February 1, 2024

Re: **Second Submission Review** – Green Valley Ranch East Site Plan No 6 Amdt 1 – Site Plan Amendment and Replat
Application Number: **DA-1662-33**
Case Numbers: 2023-3055-00; 2021-4012-01

Second Submission Review

SHEET 1 OF 2

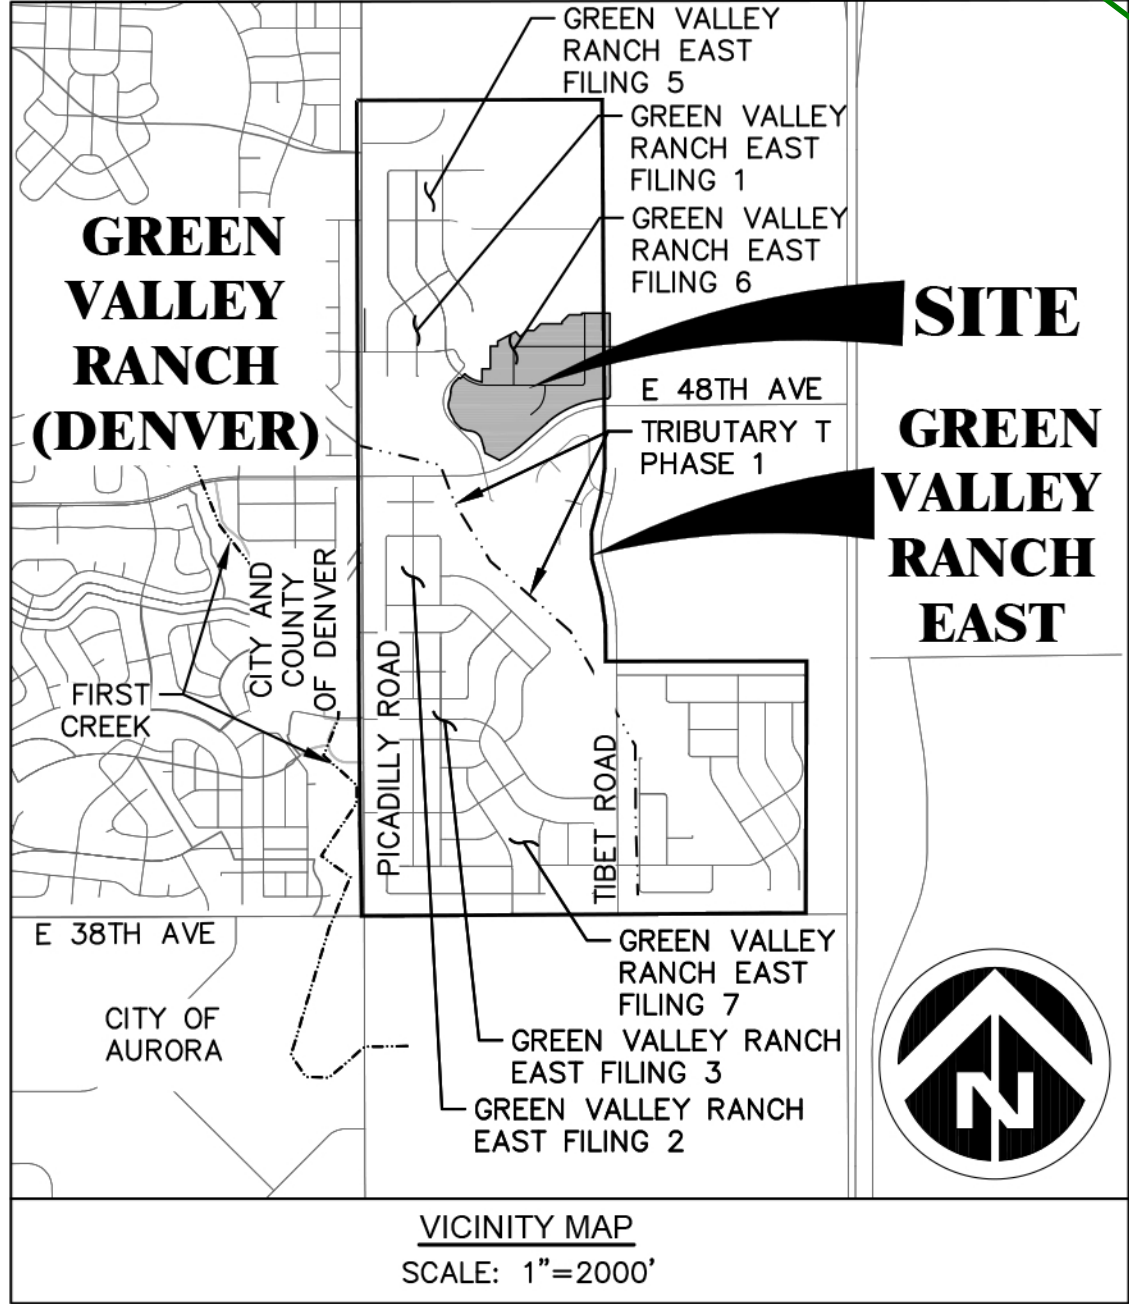
If shown include
Reception Number, If
released do not show.

SEE DETAIL

If shown include
Reception Number, If
released do not show.

If shown include
Reception Number, If
released do not show.

THE UE DESIGNATION HERE IS
CORRECT TO ANTICIPATE
ELECATRICA AS WELL AS GAS
IN THIS AREA.

GREEN VALLEY RANCH EAST
SITE PLAN #6
OVERALL SITE PLAN

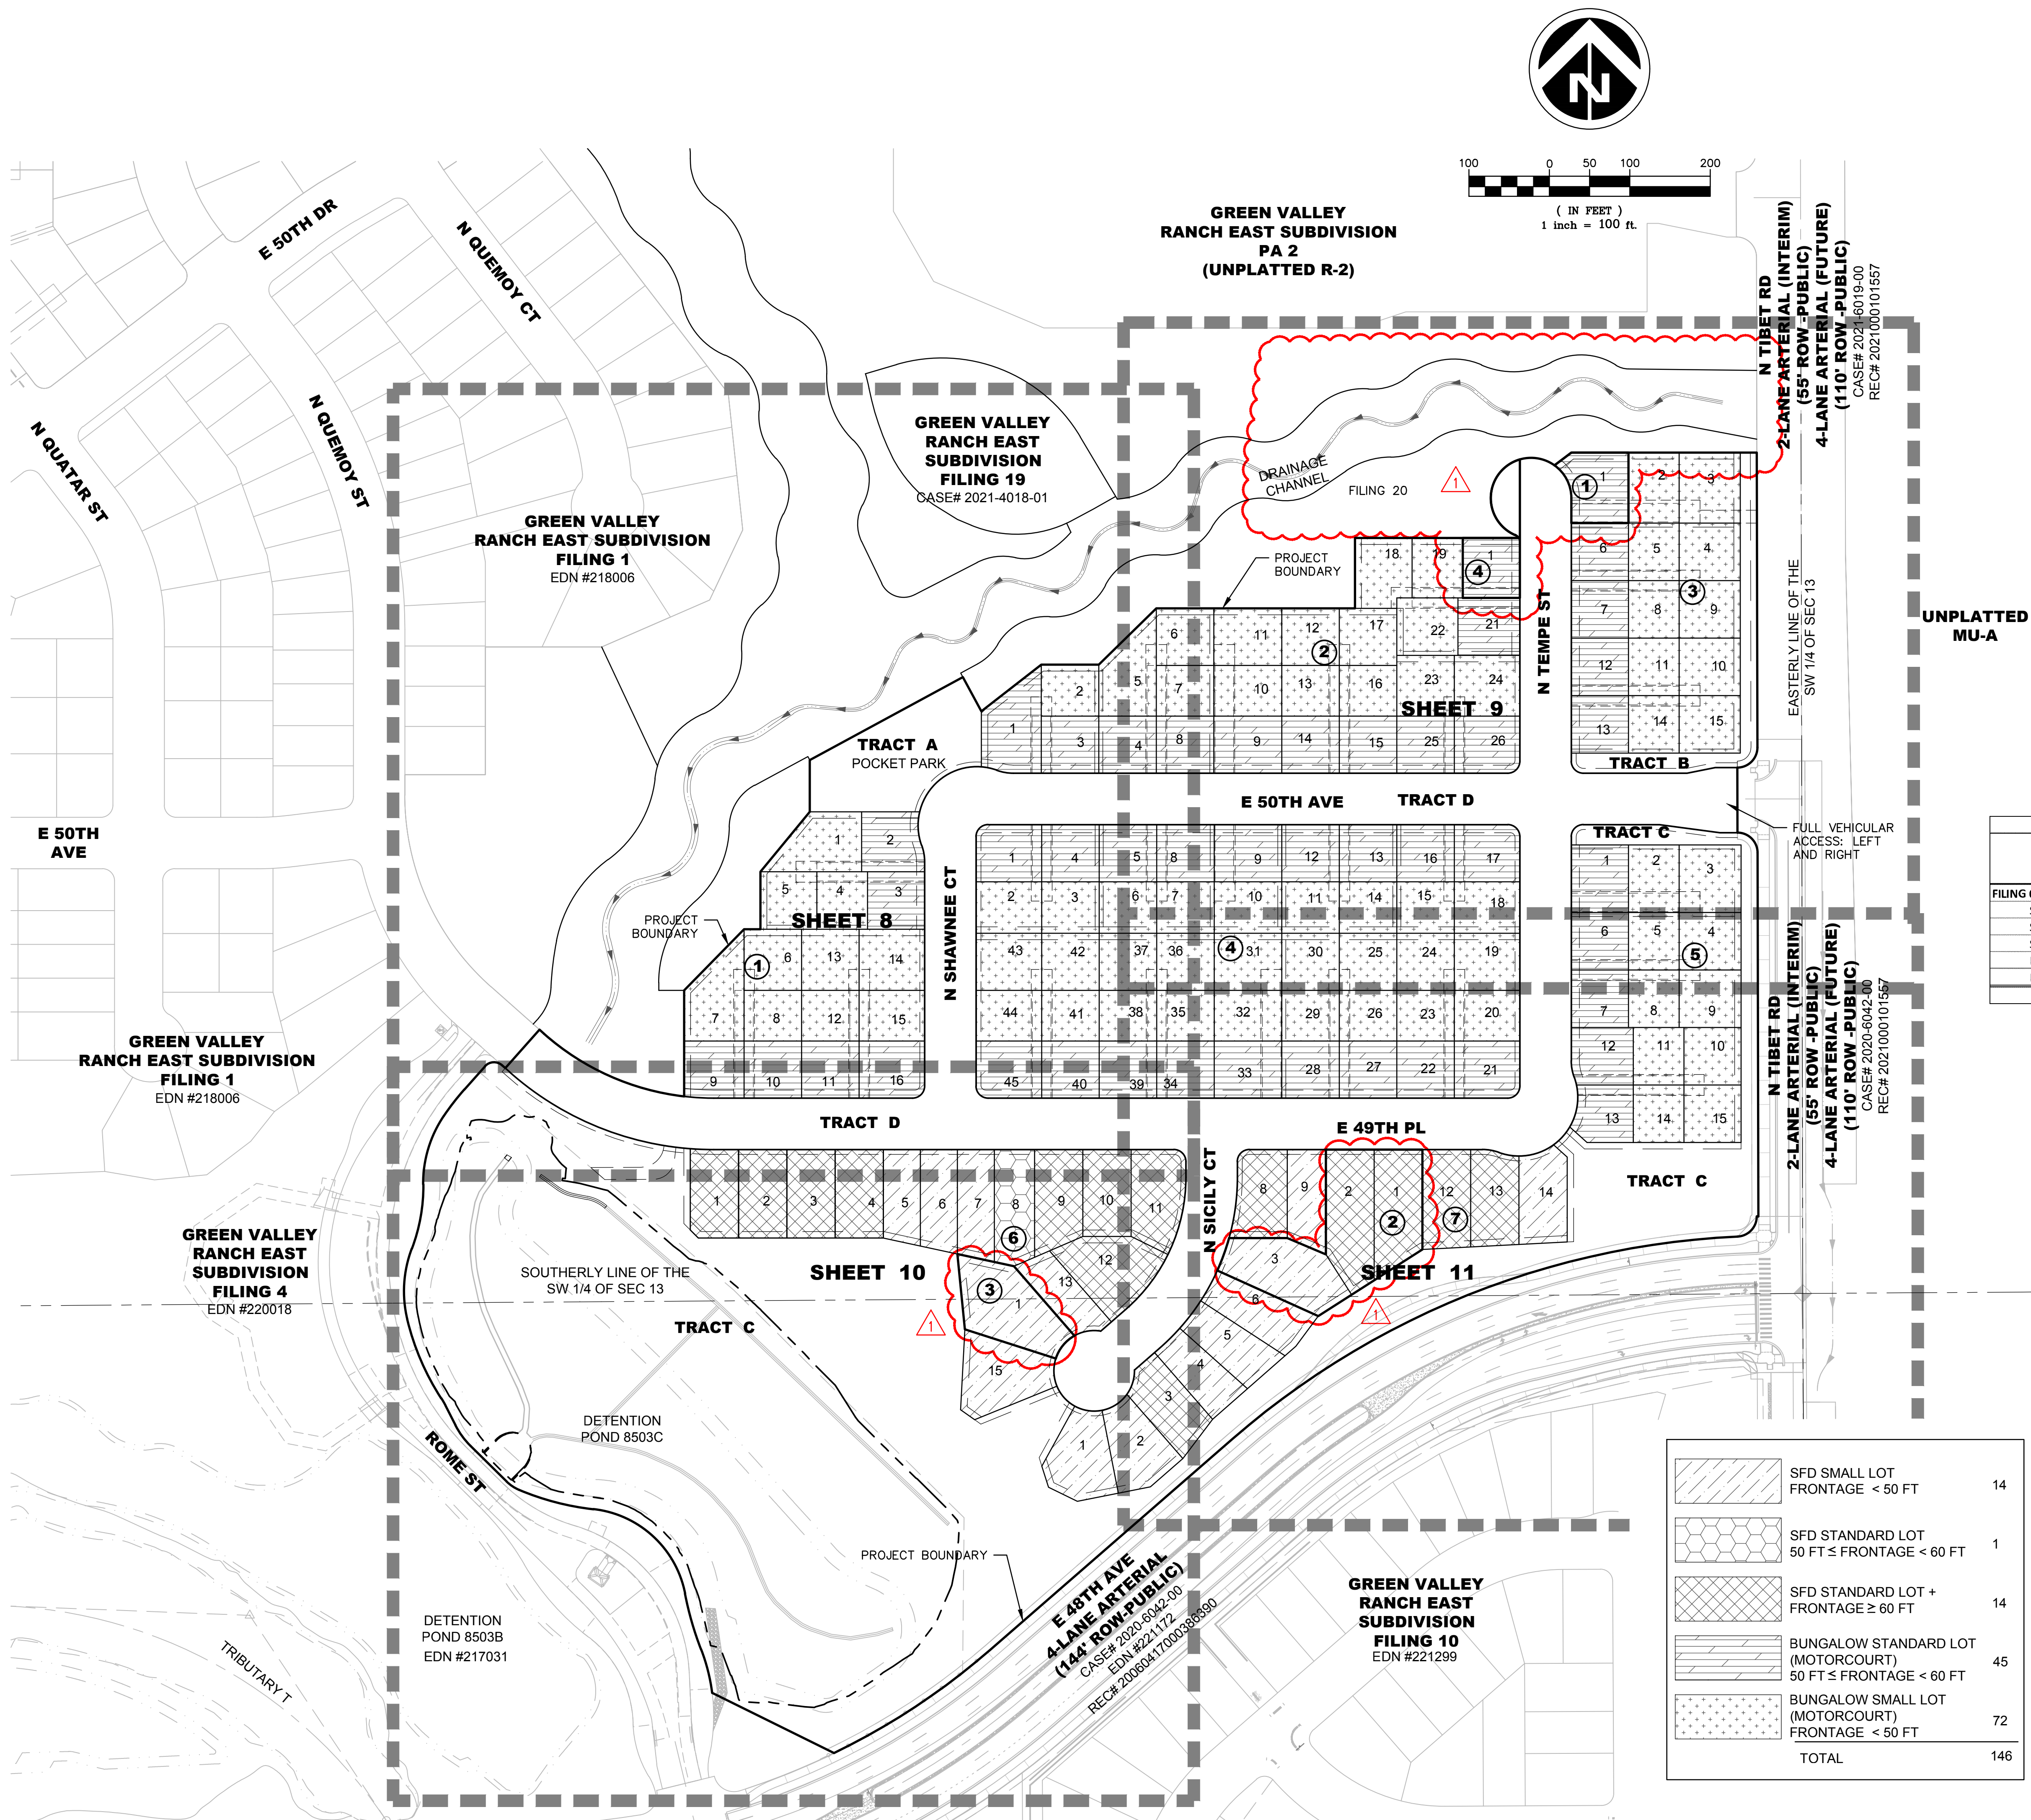
Please add subdivision name here.

We're leaving the title as-is. This opposes direction we received from Maurice Brooks on previous site plan submittals for GVRE

Sheet Number: 9

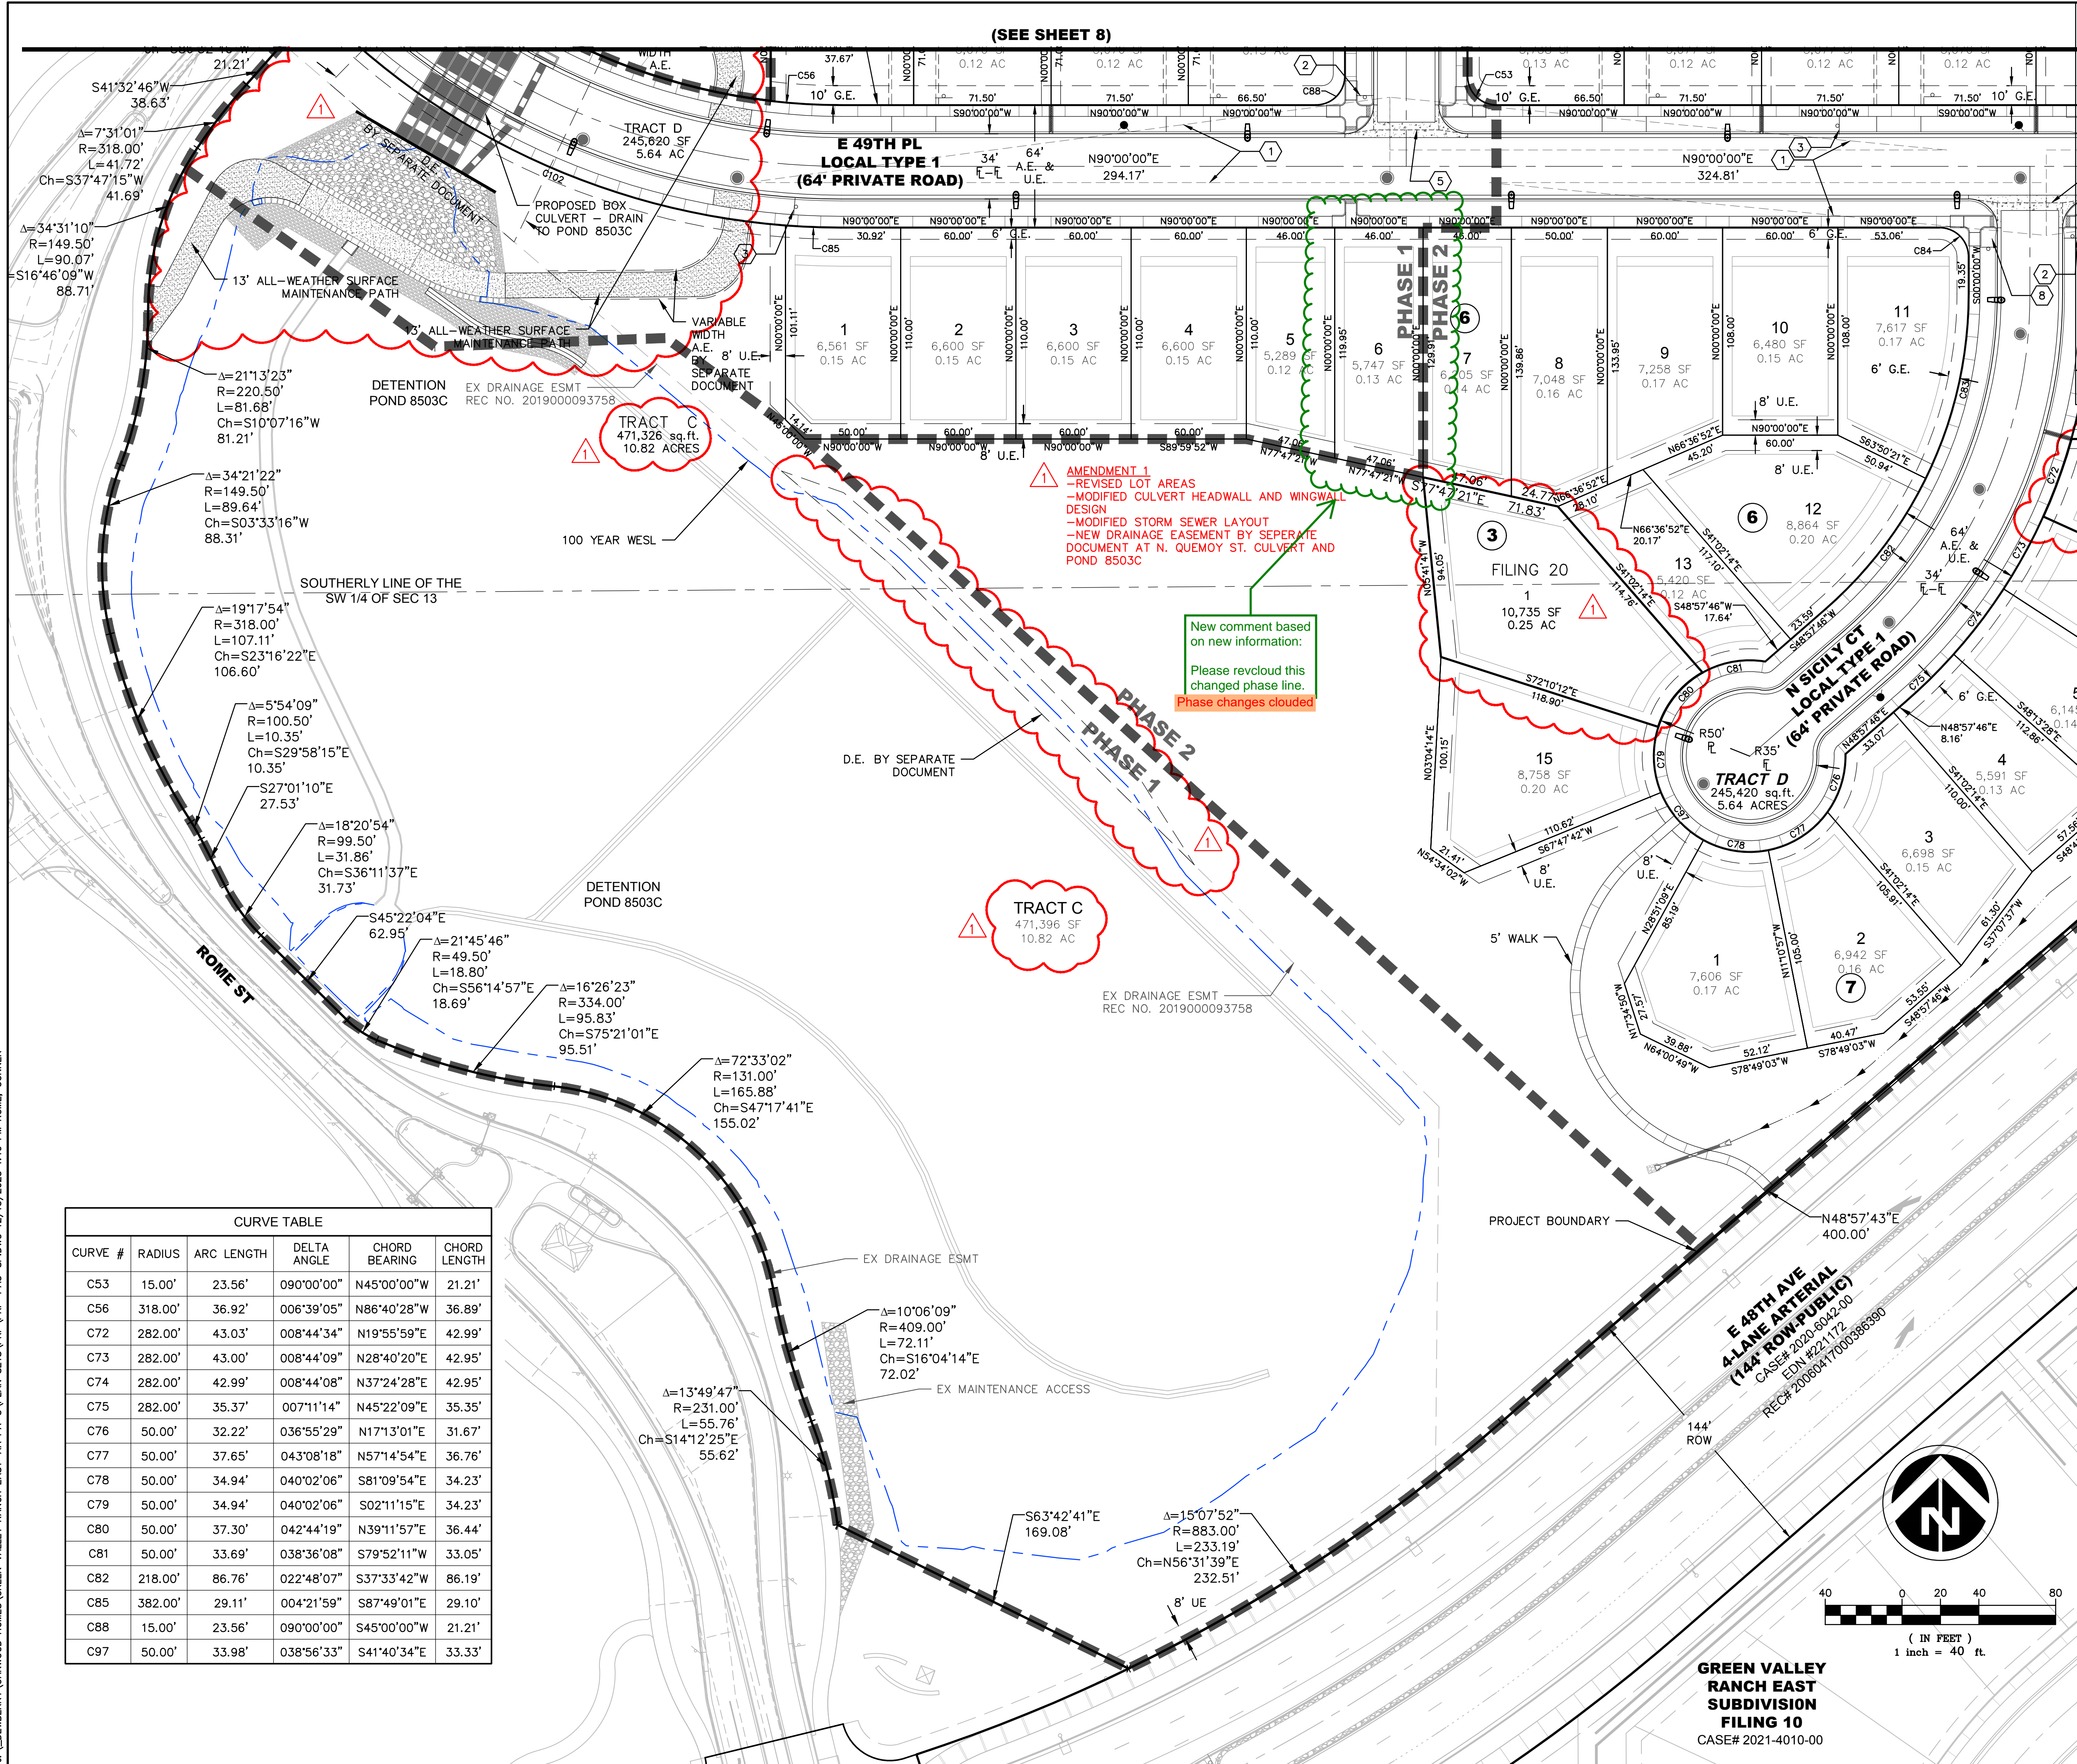
If you are requesting a variance for the flowline and property radii, please add a leader here stating that "a variance will be requested for...."

New comment
based on new
information:

Please add a revision cloud to any changed phase lines.

Will there be a mail kiosk amenity? If so, please provide an accessible route to the mail kiosks and details. Within this detail show adjacent street, vertical/mountable curb, curb ramp from street to sidewalk, width of sidewalk. The detail shall convey information that demonstrates compliance with ADA and Postal regulations that includes units of measurements and scales, and cross referencing. Within example detail shown below include adjacent street or parking area serving the mail kiosks, vertical/mountable curb, curb ramp from street to sidewalk, width of sidewalk. The detail sheet must include the type of Residential Mailbox Cluster Kiosk and the base detail.
